Service Bulletin No. 308

MODEL D / E / J Series Coaches	TYPE Field Change Program	SECTION/GROUP 13-Transmission	DATE Dec.16, 2008
SUBJECT ZF SOFTWARE UPDATE CAMPAIGN FOR CELL PHONE & RADIO INTERFERENCE			
CONDITIONS

Software Update campaign because of cell phone and radio interference (NHTSA no.06E100)

Figure 1. NO cellular phone decal.

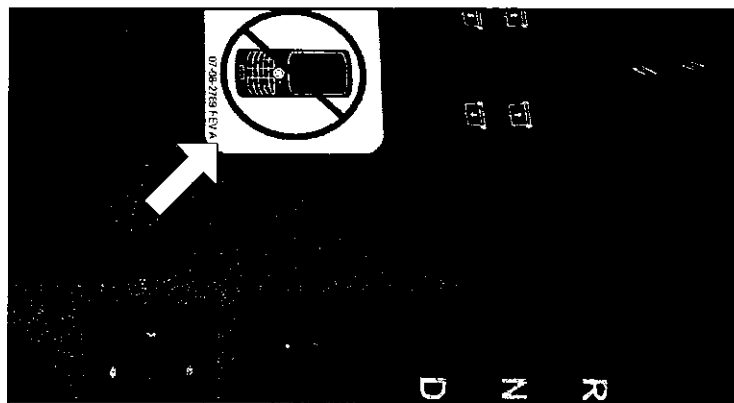
The only part required for this change is the 07-08-2789 Decal.

Installation of a warning sticker onto the dashboard area

- to avoid any malfunction due to the use of electronic equipment (ZF part no.: 1348 753 101)
